MANDATORY SERVICE BULLETIN

Service Bulletin No. 565 Engineering Aspects are FAA Approved

SUBJECT: Diaphragm-Type Fuel Pump Inspection/Replacement

Figure 1

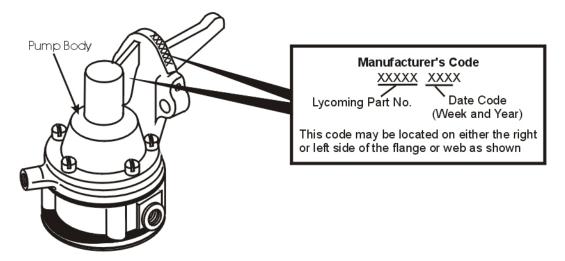
To identify affected pumps, check the manufacturer's code scribed on the pump. (See Figure 1.) If the number is 154733201, the pump is affected and must be replaced prior to next flight.

If your Lycoming engine has a diaphragm-type fuel pump with Lycoming P/N LW-15473 installed, and has a date code of 3201, the pump must be replaced prior to next flight.
